Urban Design Peer Review

Western Sydney University - Bankstown Campus Proposal

Prepared for City of Bankstown Canterbury

Figure 21. WSU's Typical Floor Plate (Source: F 190814 Updated Draft Architectural Drawings, Western Sydney University Bankstown City Campus Supplementary Planning Information Package, by Lyons, 12 August 2019)

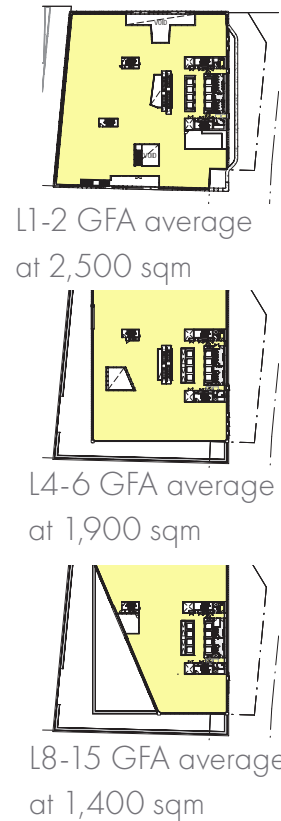
A review of the architectural plans indicates that the GFA for each level varies as the building is articulated - ranging from 811 sqm at the Top level, to 2,544 sqm for Level 2. The typical floor plate size is approximately 1,900 sqm for Level 4 to Level 6, and approximately 1,400 sqm for Level 8 to Level 15.

The proposed floor plate sizes are justified in the proposal as being required to viably incorporate the various functional uses of a vertical campus. The precedent studies of similar vertical campus developments provide a wide variation of building, floorplate and area sizes, (due to varied site conditions and urban environments and constraints) making direct comparisons challenging.

On balance, the proposed floor plate sizes are broadly consistent with those found in the precedents, and as such can be supported.

Figure 23. Building Setback - Plan Diagram
(Source: Tract 2019)

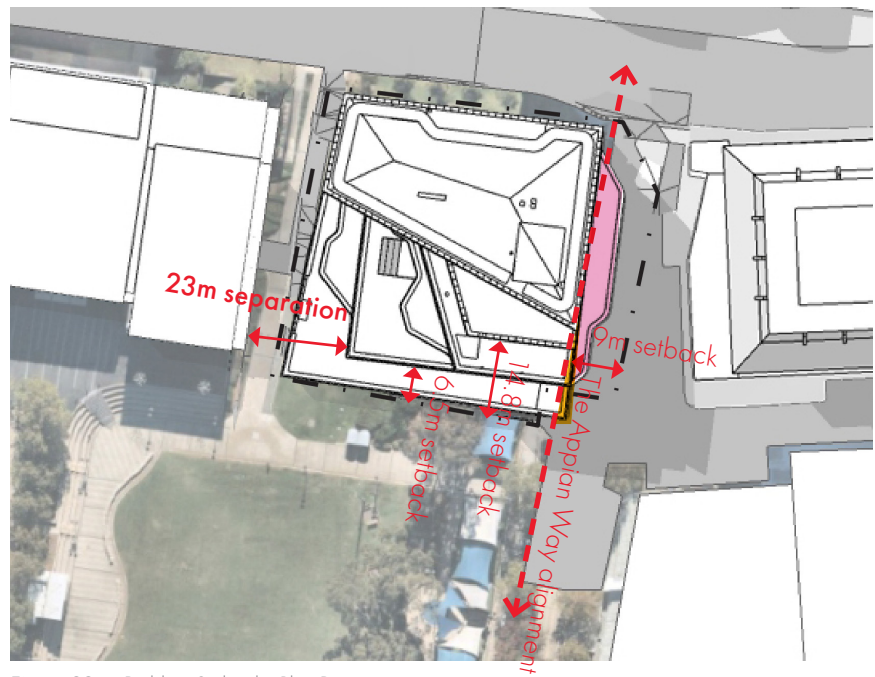
It is recognised that this proposed built form design incorporates the following setbacks on each of the east, south and west sides.

- A 9m setback to the eastern boundary with a minor building intrusion into The Appian Way alignment. There is some complexity to the eastern interfaces as the land title extends into The Appian Way as illustrated in Figure 23. However, the proposal generally maintains a clear and open view along The Appian Way - Addresses Design Principle DP02.
- The upper portion of the proposed tower is rotated and setback approximately 6.5m-14.8m on the southern side. The proposal's stepping form at Levels 3 & 7-13, which reduces the bulk facing the Park, provides a relatively slender profile. (These setbacks also assist with the minimisation of overshadowing to the public domain, as outlined in Section 5.0 of this report) - Addresses Design Principles DP03, DP-AD01.

Figure 24. Building Setback - The Appian Way Street View (Source: Tract 2019)

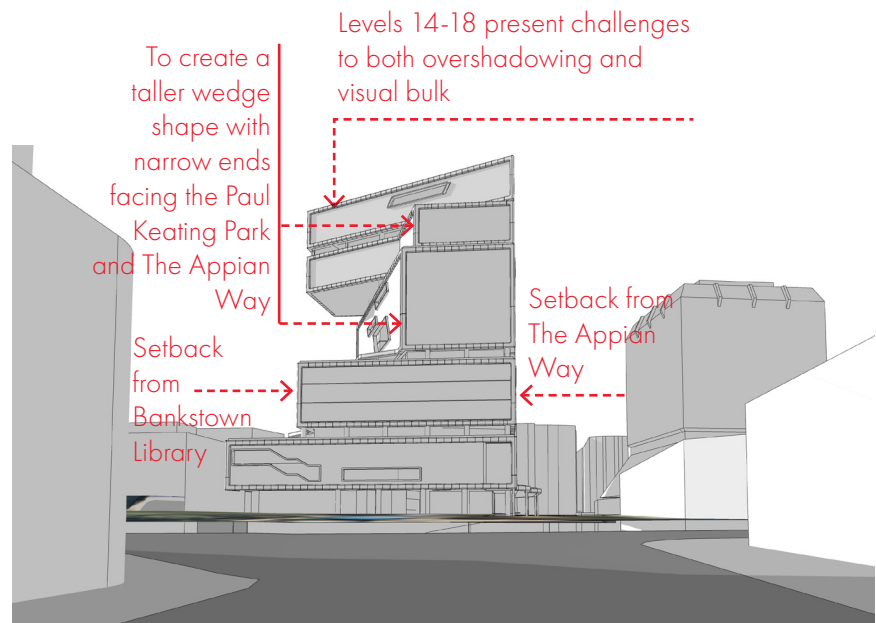
The proposed setbacks up to Level 13 provide visual articulation and relief for the built form when viewed at street level and also on key view lines within the city centre, and as such are considered appropriate.

However, the articulation and building setbacks above this to Levels 14-18 present challenges to both overshadowing and visual bulk and can be supported with amendments (outlined in "Design Implications" on page 49 of this report).

Figure 30. PKP Shadow Diagram Winter Solstice [10am-12pm, 21st June] (Source: Tract 2019)

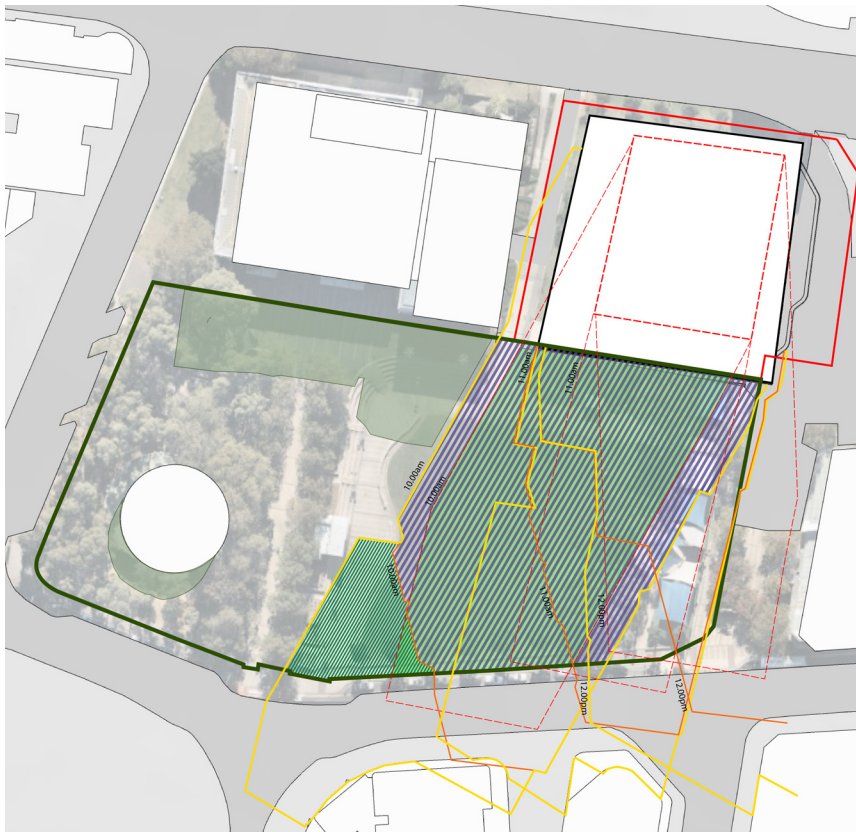
- All three scenarios achieve at least **3 hours** direct sunlight to more than **50%** of the **total** Park area, between **10am - 2pm** on Winter Solstice.
- Compared with Scenario 2 and 3, Scenario 1 achieves one more hour direct sunlight to more than 50% of the total Park area at 10am due to its reduced building height and bulk.

Figure 33. The Appian Way Shadow Diagram Winter Solstice [12pm-4pm, 21st June]
(Source: Tract 2019)

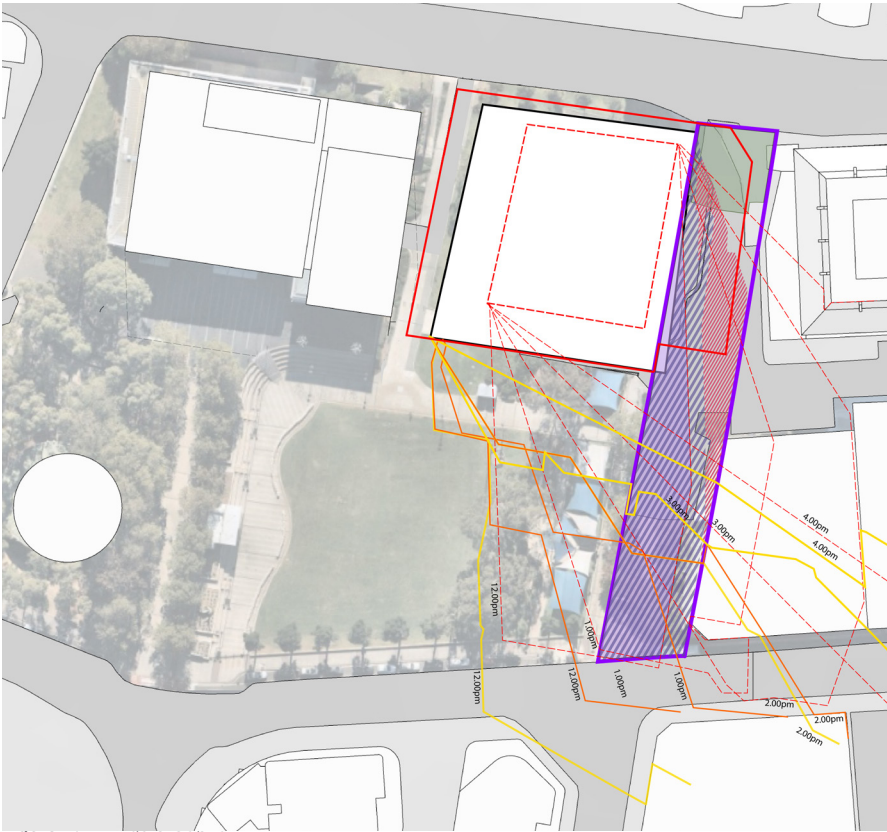
Between 12pm - 4pm, all three scenarios achieve direct sunlight to approximately 50% of The Appian Way. All three scenarios provide good solar access to more than 70% of the retail facade at the southern end of The Appian Way.

Figure 36. View 1 north from The Appian Way
(Source: Tract 2019)

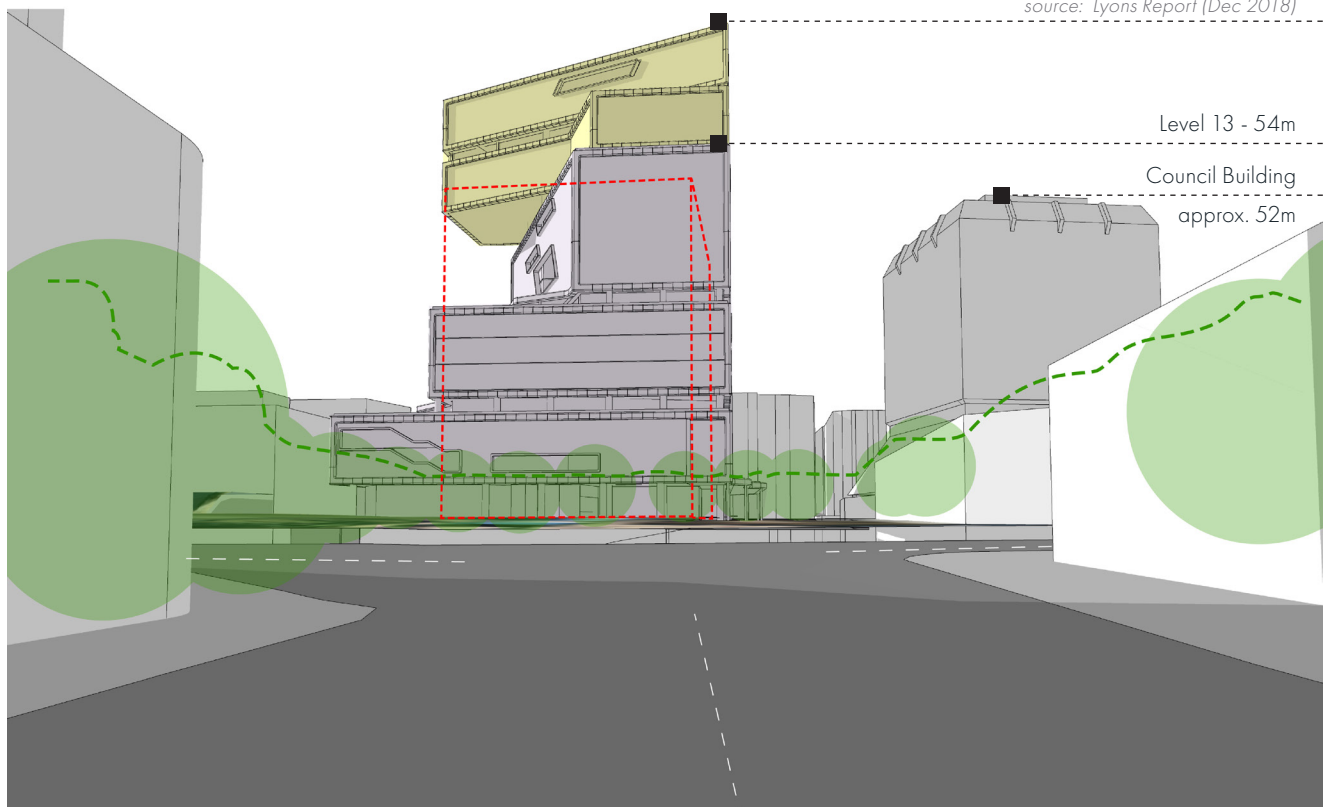
This viewpoint along The Appian Way demonstrates the visual impact of the proposal's stepping form at Levels 3, 7 & 13, which reduces the bulk facing the Park and provides a relatively slender profile.

Figure 38. View 3 east along Rickard Road
(Source: Tract 2019)

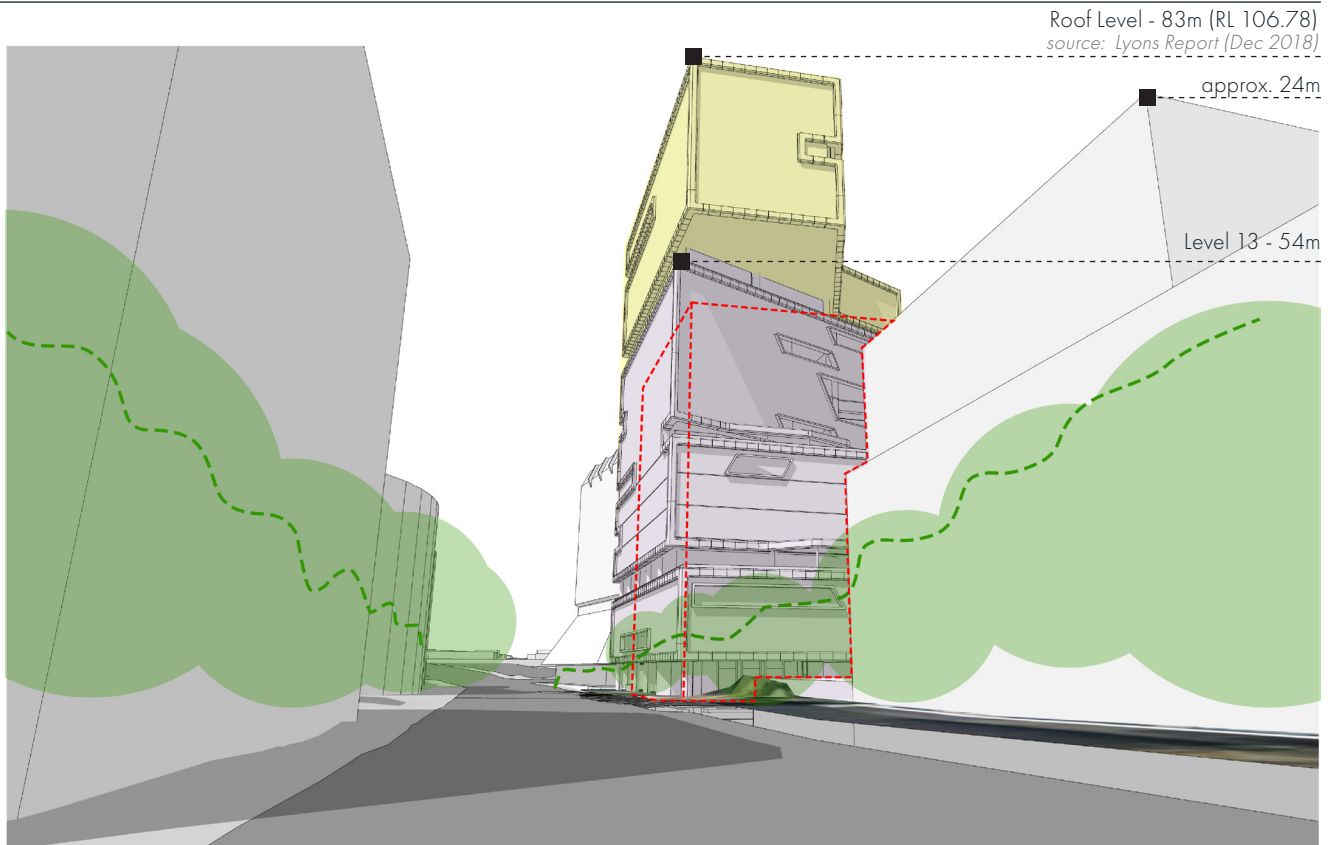
View 3 along Rickard Road presents a comparatively slender visual profile, due to the orientation of Levels 14-18 from this perspective.

Figure 39. View 4 west along Rickard Road
(Source: Tract 2019)

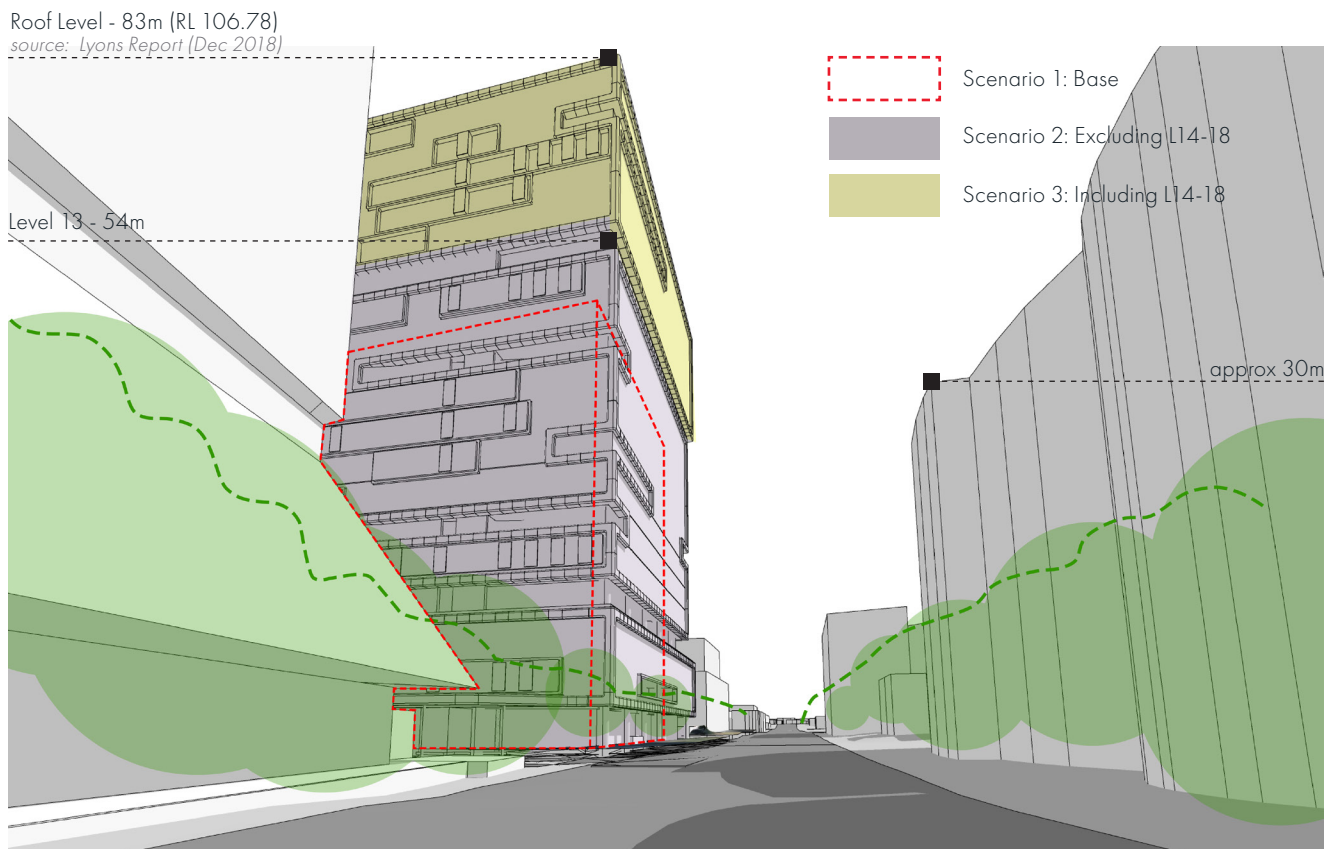
There is no stepping back of the form facing Rickard Road, as evident on the adjacent existing buildings. Therefore the height of the building from Rickard Road is urbanised and immediately apparent. The profile of the building is visually varied in form and provides visual interest on the west elevation facing this viewpoint, which is supported.

Whilst the facade is treated to provide visual interest, the stepping is not visible from the west, and the building's bulk appears large and solid.

Figure 42. Lyons Updated Ground Level Plan
(Source: Lyons Updated Draft Architectural Drawings 5 (F 190814))

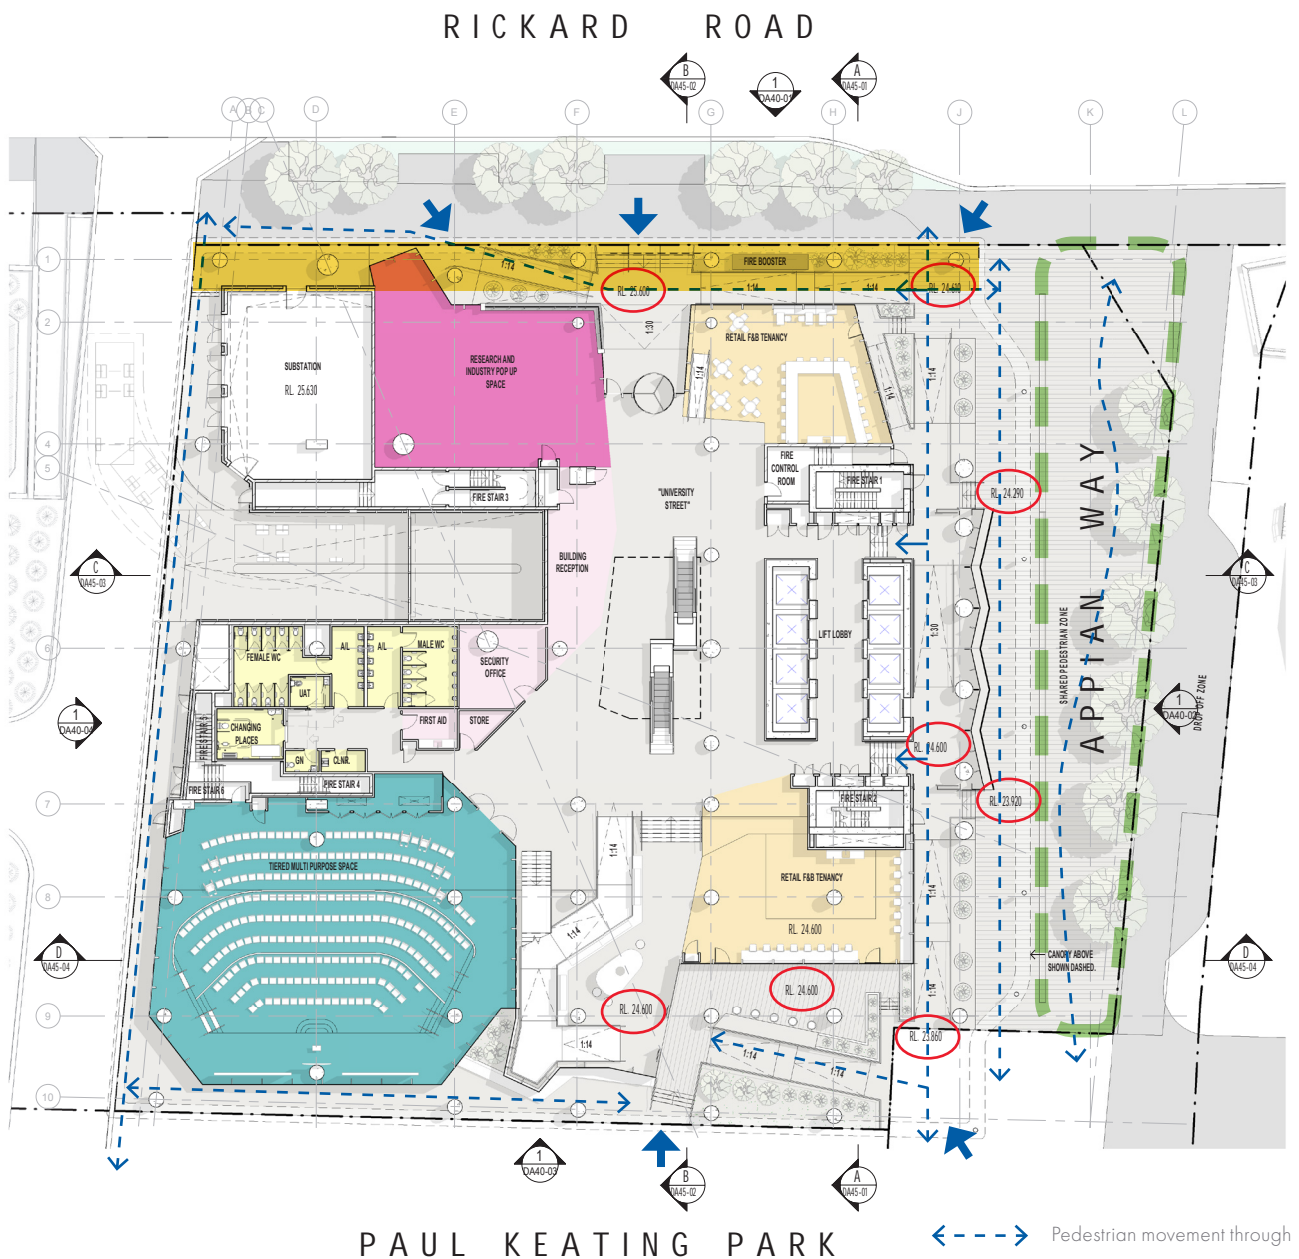
- A continuous pedestrian movement is proposed along The Appian Way frontage between WSU and the linear park for pedestrian ease of movement.
- A glazed awning is proposed at ground level along The Appian Way frontage, which provides the weather protection for pedestrians benefit. It also helps to mitigate the wind impact at street level as recommended by *Pedestrian Wind Environment Study*, by Windtech (May

- Deep soil zone and tree planting are proposed along The Appian Way frontage, which would contribute to the urban tree canopy and provide shades and visual interest for pedestrian, as well as reduce wind impact. However, the limited solar access to The Appian Way may constrain tree and vegetation growth. Consideration needs to be given to the selection of tree species which will prosper in

- Ground level retail spaces and main entry lobby along The Appian Way provide street activation opportunities.
- Street furniture, bench seating and cafe seating along The Appian Way frontage encourage the uses by

Figure 43. Lyons' Updated Ground Level Plan - Paul Keating Park Interface (Source: Lyons Updated Draft Architectural Drawings 5 (F 190814))

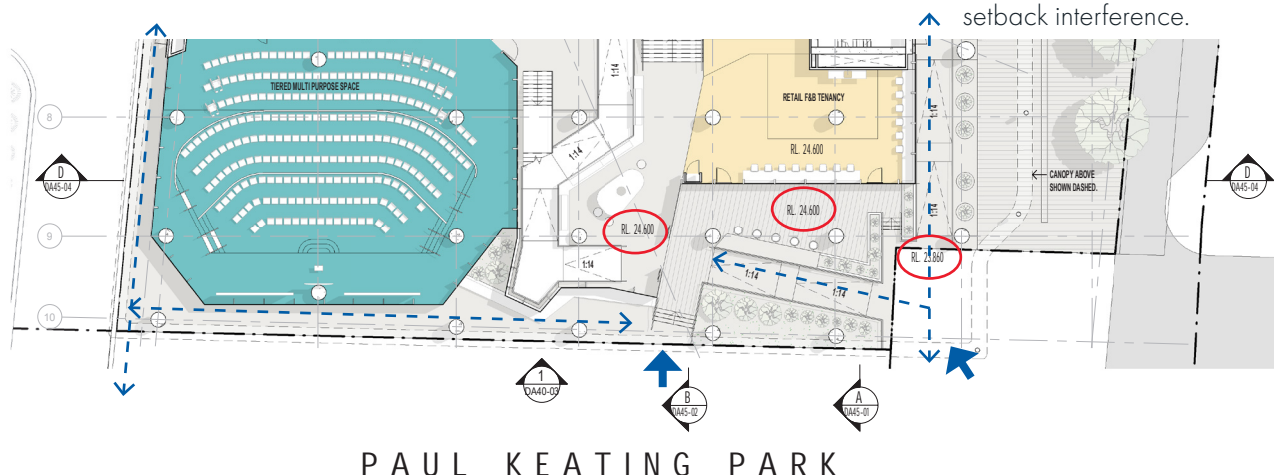
- The major pedestrian flows will arrive from Bankstown train station on the south via The Appian Way. Apart from The Appian Way entry lobby, there are two ground-level entries to WSU proposed along the Paul Keating Park interface. One is located at the south-east corner of the building, while the other is located toward the middle of the southern interface. Both entries correspond to the existing ground level. The level difference between internal and external are picked up by a series of ramps and steps, which offer smooth and equal access for all users. Refer to figure 43.
- Visual connectivity between WSU and the Paul Keating Park is enabled through the WSU entrances and ground level glazing facade.

- A ground-level colonnade is proposed along the Paul Keating Park interface to provide weather protection for the pedestrians and other users.

- Different functional spaces are programmed at the ground level alongside the Paul Keating Park interface. These include a multi purpose hall, entry lobby and retail spaces. These functional spaces provide great opportunities for activation and vibrancy on the ground level and provide passive surveillance to the Park.

Figure 45. Lyons' Updated Ground Level Plan - Rickard Road Interface [Source: *Lyons Updated Draft Architectural Drawings 5 (F 190814)*]

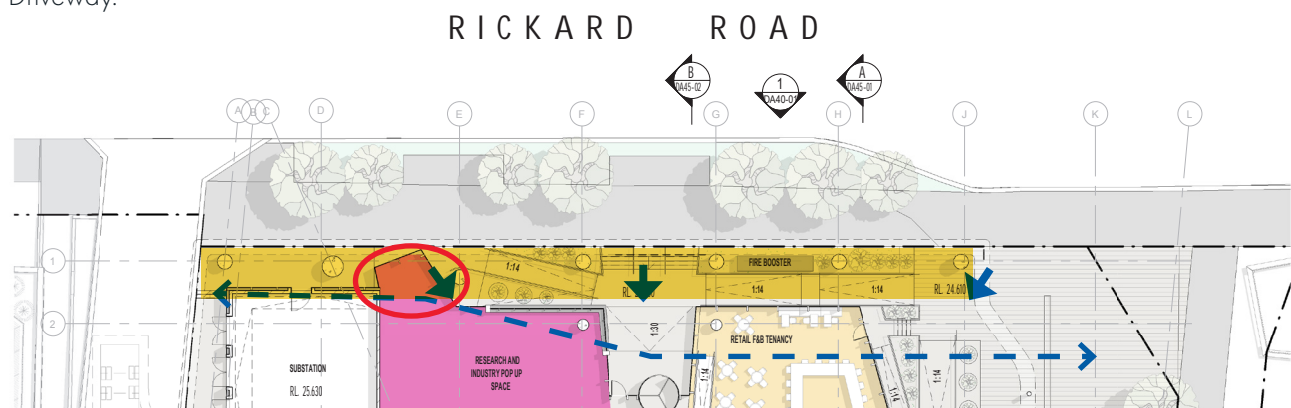
- There is a setback proposed at ground level on north side of WSU along Rickard Road, which provides the sense of alignment to both Council building on the east and the Bankstown Library and Knowledge Hub on the west.
- A series of ramps and steps are accommodated within the setback zone, which pick up the level difference between internal and external. This offers smooth and equitable access for all users. Refer to figure 45.
- A space intrudes into the setback zone, which interrupts the under-covered pedestrian movement through. It also conflicts with the design guidance of "2.3m wide pedestrian movement through within Lot Boundary" as suggested in *Bankstown Draft Complete Streets (April 2019)*. Refer to figure 44 and 45.
- Reconfiguration of the 'research and industry pop-up space' is required to avoid the front setback interference.

- Different functional spaces are programmed at ground level along Rickard Road, including university research and industry pop-up spaces, entry lobby and retail. These spaces provide additional opportunities for ground level activation and provide passive surveillance to Rickard Road.
